INDIVIDUAL WATER AND WASTEWATER SYSTEMS PROGRAM
APPLICATION FOR SERVICES

BOUNDARY & PHYSICAL SURVEY
of
12125 RANBURNE ROAD
CLEAR CREEK TOWNSHIP, MECKLENBURG COUNTY, N.C.

Re: 12125 Ranburne Road
File: 10475
Tax Parcel: 197-031-36

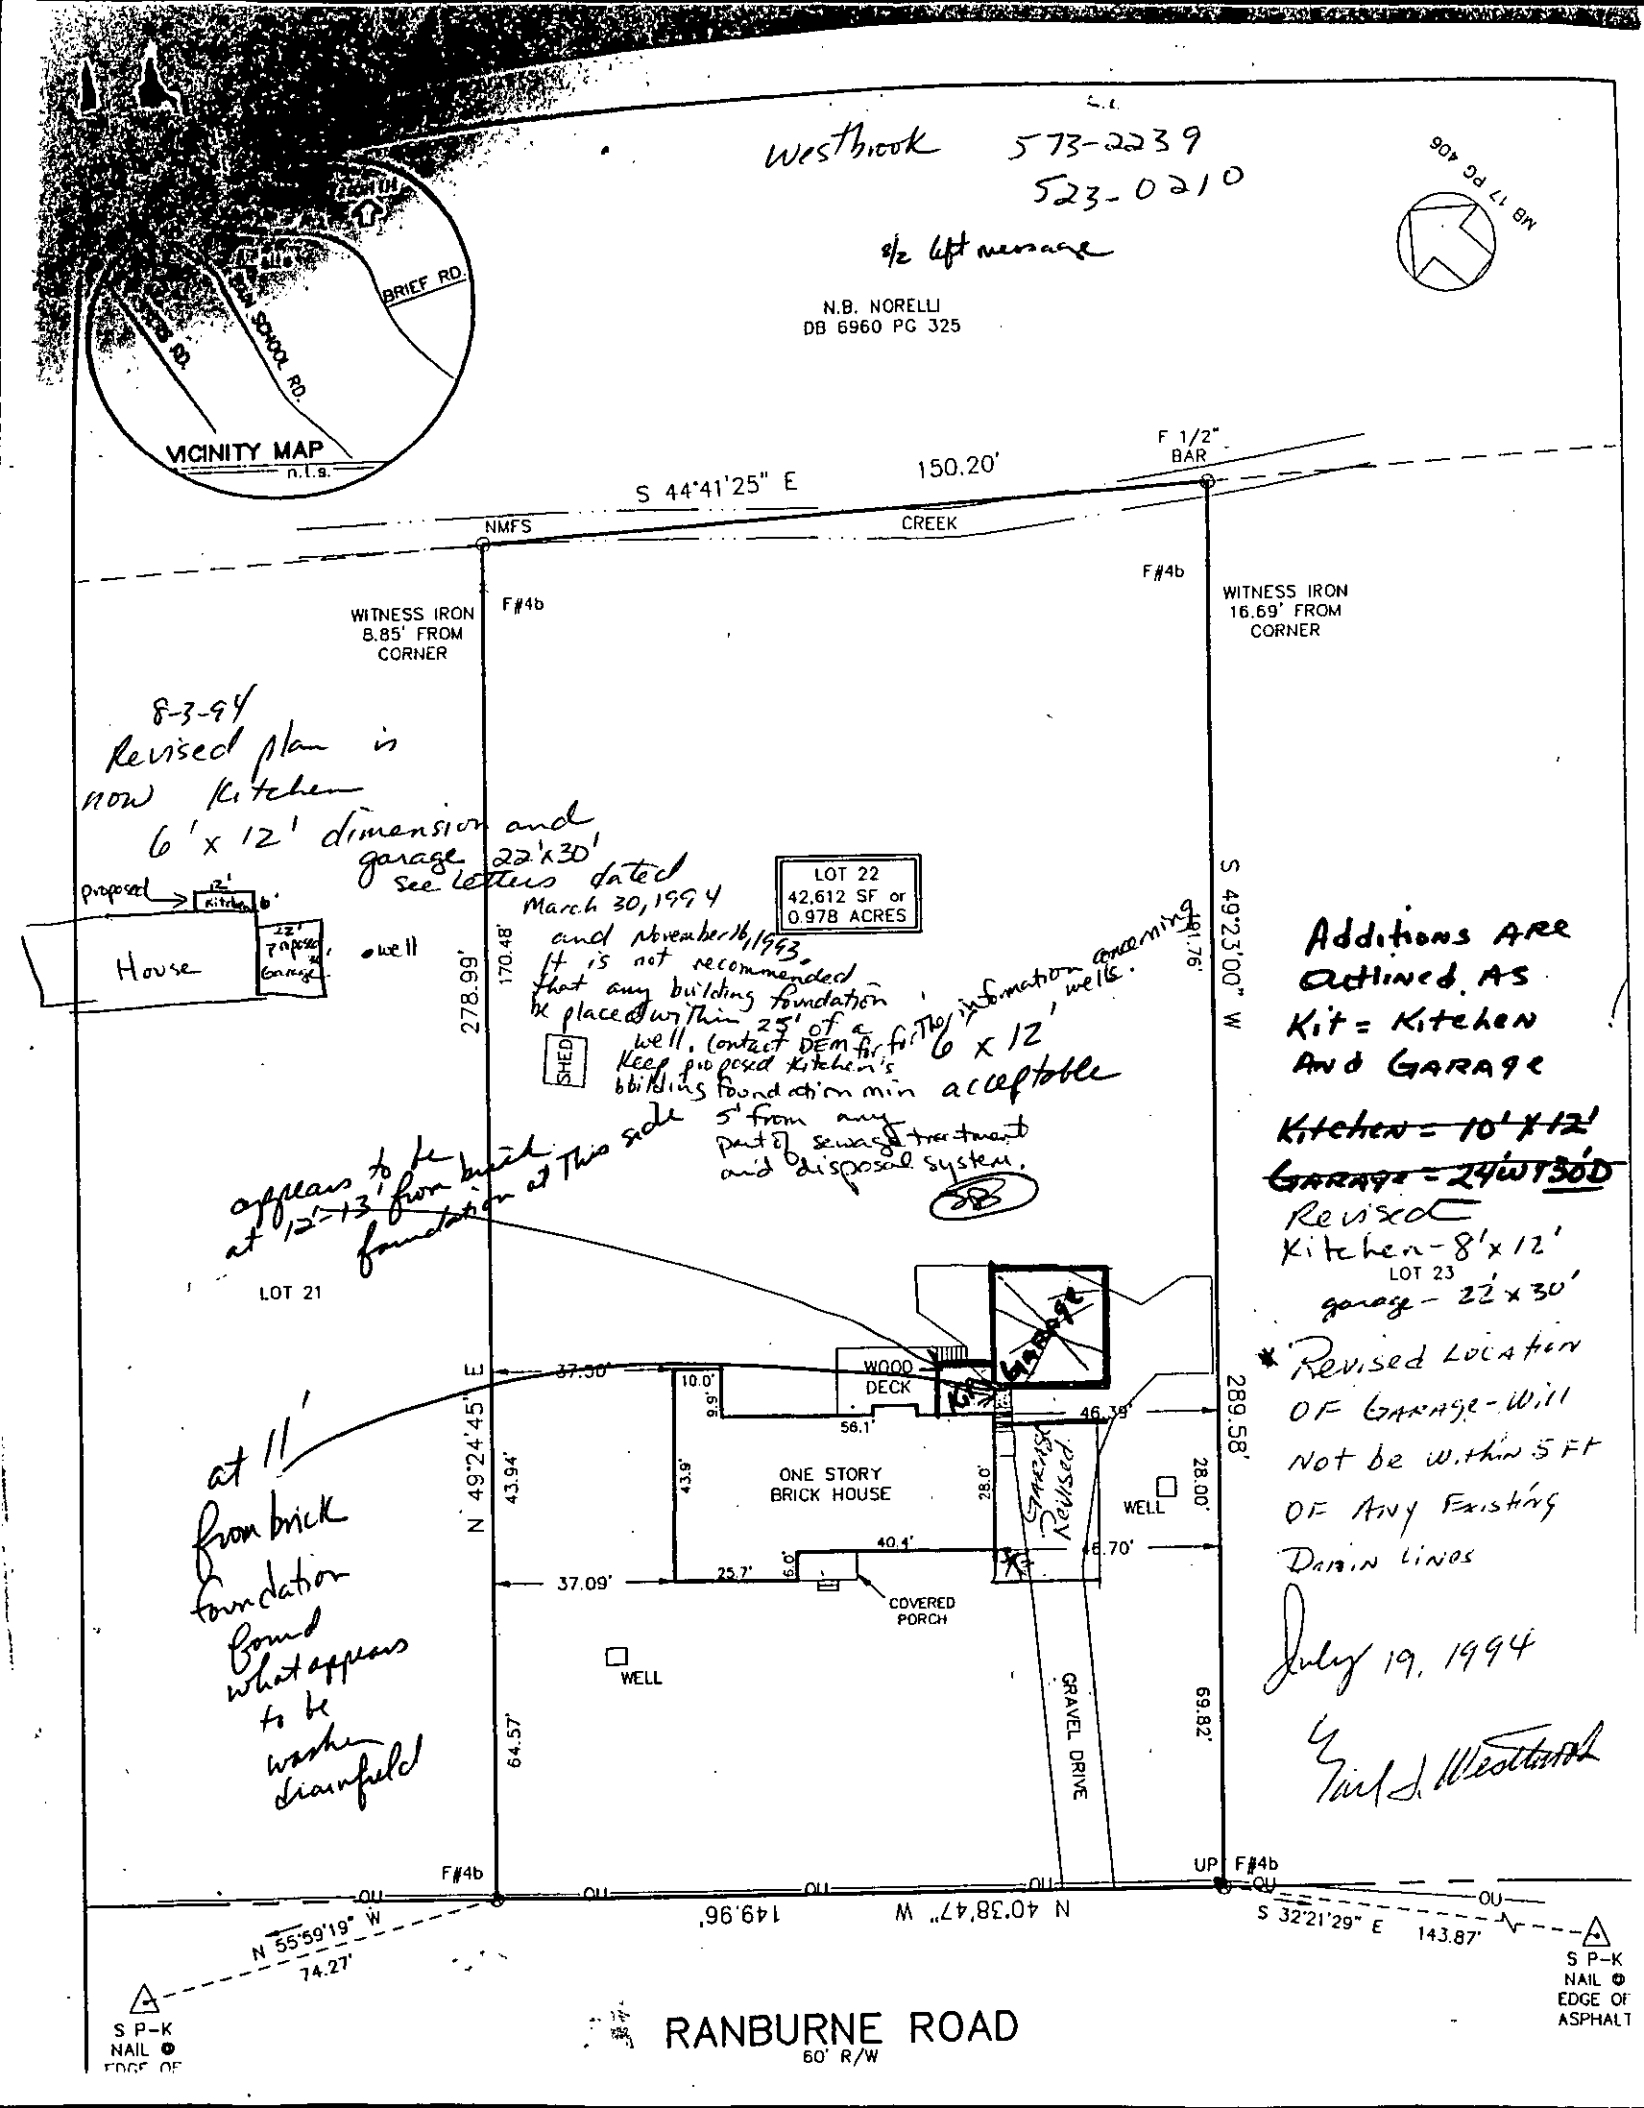
Westbrook 573-2239
523-0210
s/c left message
N.B. NORELLI
DB 6960 PG 325
MB 17 PG 406
VICINITY MAP
n.t.s.
BRIEF RD.
SCHOOL RD.
S 44°41'25" E
150.20'
F 1/2" BAR
NMFS
CREEK
F#4b
WITNESS IRON 8.85' FROM CORNER
WITNESS IRON 16.69' FROM CORNER
8-3-94
Revised plan is now Kitchen 6'x12' dimension and garage 22'x30' see letters dated March 30, 1994 and November 16, 1993.
proposed
House
well
LOT 22
42,612 SF or

0.978 ACRES
SHED
It is not recommended that any building foundation be placed within 25' of a well. Contact DEM for further information concerning well. Keep proposed kitchen's building foundation min acceptable 5' from any part of sewage treatment and disposal system.
6 x 12'
S 49°23'00" W

289.58'
278.99'
170.48'
appears to be at 12'-13' from brick foundation at this side
LOT 21
LOT 23
Additions ARE outlined AS Kit = Kitchen AND GARAGE
~~Kitchen = 10'x12'~~
~~GARAGE = 24'x30'~~
Revised Kitchen - 8'x12'
garage - 22'x30'

* Revised Location OF Garage - Will Not be within 5 FT OF Any Existing Drain Lines
July 19, 1994
Earl J. Westbrook
WOOD DECK
Garage
Garage Revised
ONE STORY BRICK HOUSE
WELL
COVERED PORCH
GRAVEL DRIVE

-The building foundation for the proposed addition is not the required minimum distance of five feet from the sewage treatment and disposal system.

Presently, the well appears to be within 50' of the sewage treatment and disposal systems. It is recommended that the well be moved so that it meets the minimum separation distance requirements or an alteration be made to the sewage treatment and disposal system.

... use existing System. Must keep proposed building foundation minimum 5' from any part of sewage treatment and disposal system. Recommend keeping min 25' from any well.

Possible ways to enlarge the kitchen and add a garage would be to relocate the proposed addition so that it will be the minimum distance of 5' from the sewage treatment and disposal systems. You may wish to consider an alteration to the sewage treatment and disposal system which specifically services the washing machine wastewater. The alteration would entail relocating this system. It is not recommended to interfere with the septic tank system which accommodates all the wastewater from the house except the washing machine.

BOUNDARY & PHYSICAL SURVEY
of
12125 RANBURNE ROAD
CLEAR CREEK TOWNSHIP, MECKLENBURG COUNTY, N.C.

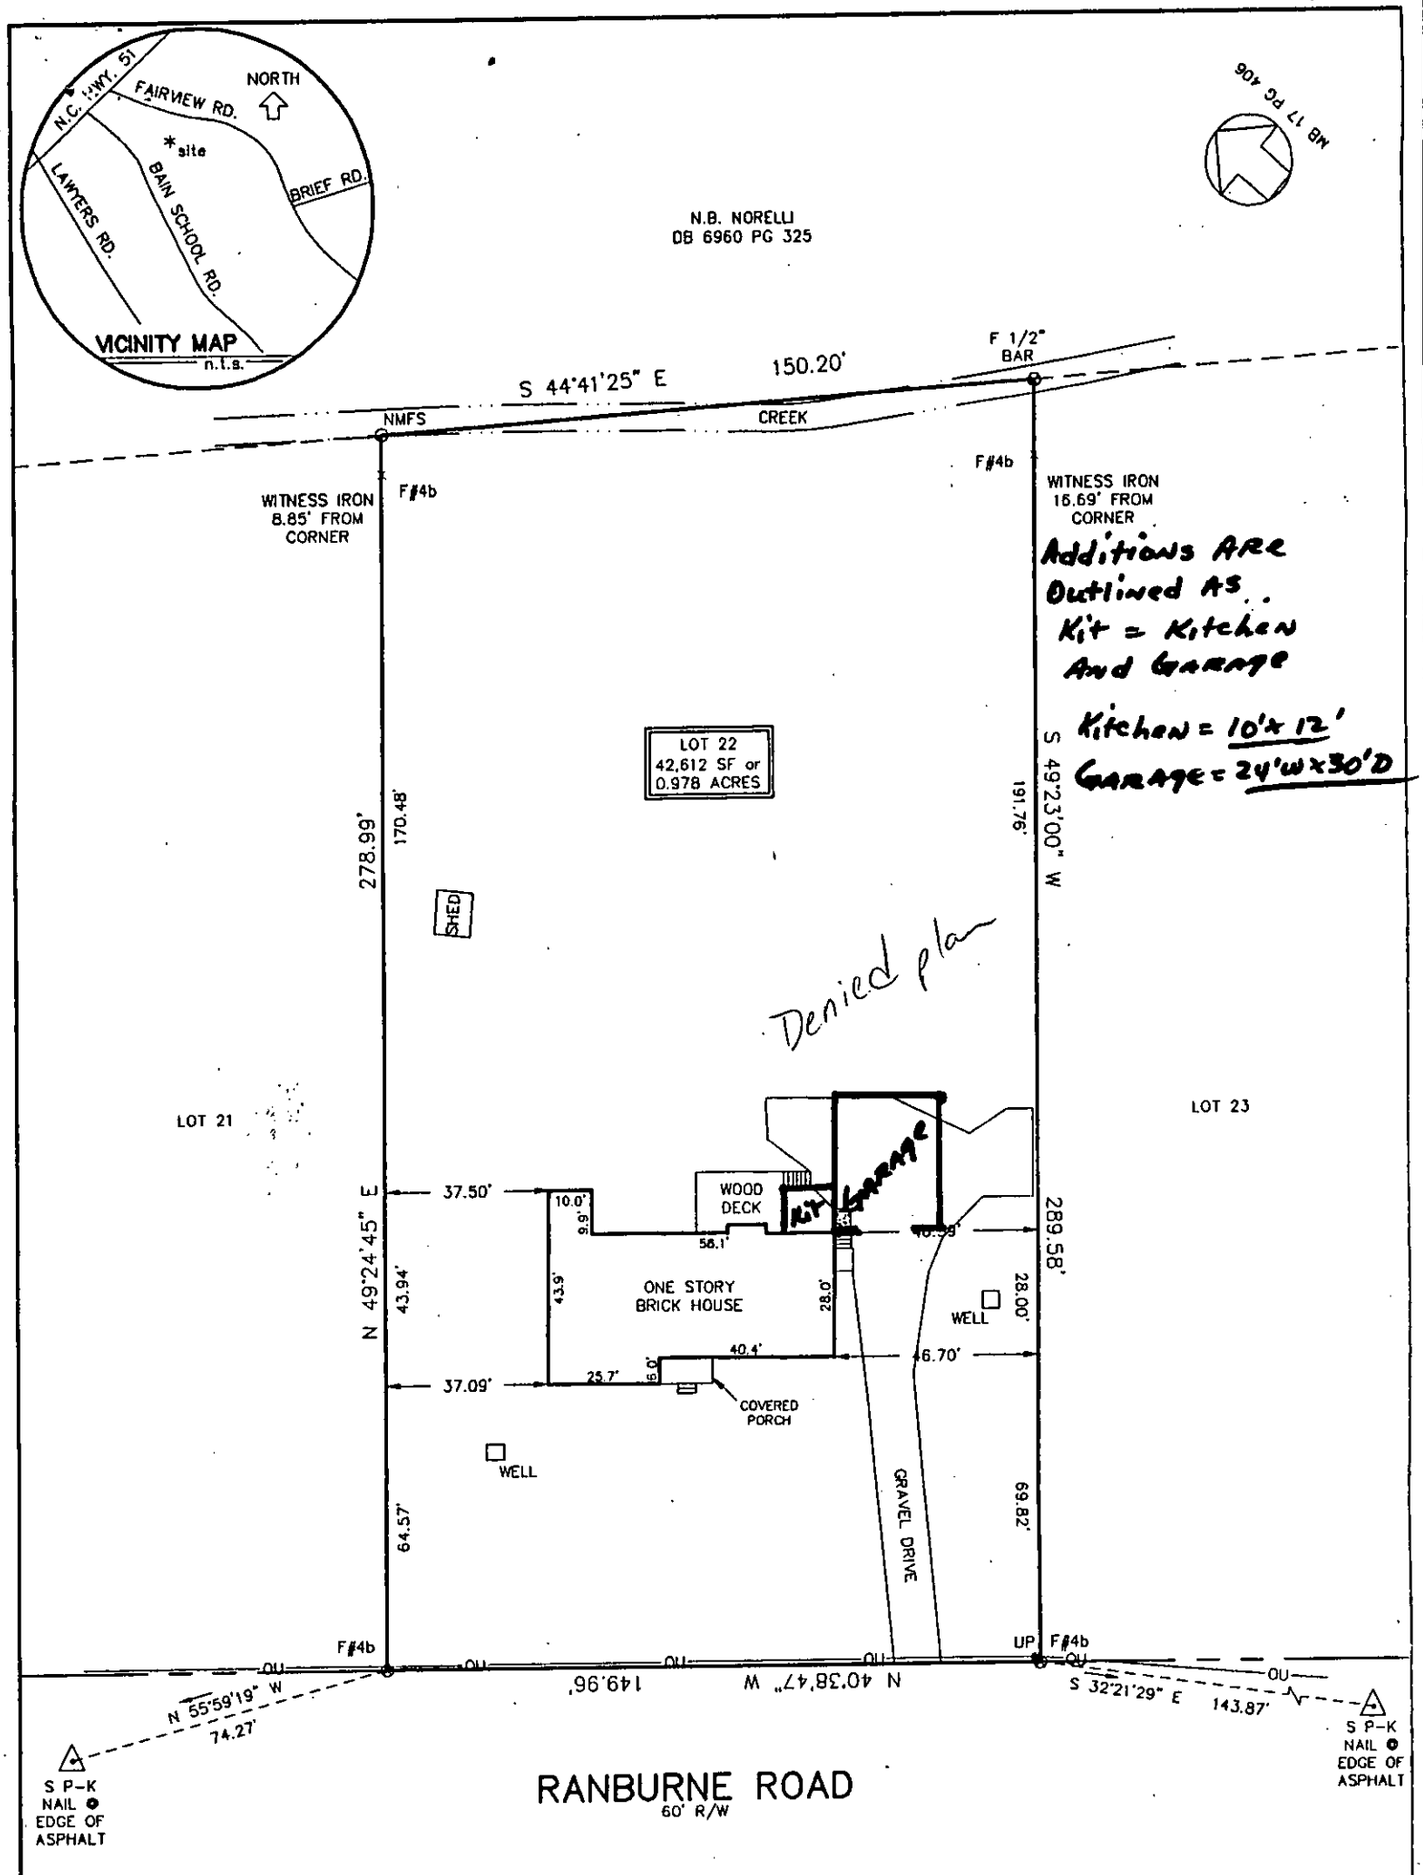
-The building foundation for the proposed addition is not the required minimum distance of five feet from the sewage treatment and disposal system.

Presently, the well appears to be within 50' of the sewage treatment and disposal systems. It is recommended that the well be moved so that it meets the minimum separation distance requirements or an alteration be made to the sewage treatment and disposal system.

Possible ways to enlarge the kitchen and add a garage would be to relocate the proposed addition so that it will be the minimum distance of 5' from the sewage treatment and disposal systems. You may wish to consider an alteration to the sewage treatment and disposal system which specifically services the washing machine wastewater. The alteration would entail relocating this system. It is not recommended to interfere with the septic tank system which accommodates all the wastewater from the house except the washing machine.

In order to proceed with this application, you will need to submit revised plans and/or submit the appropriate fee with request for an alteration to the sewage treatment and disposal system to this Department.
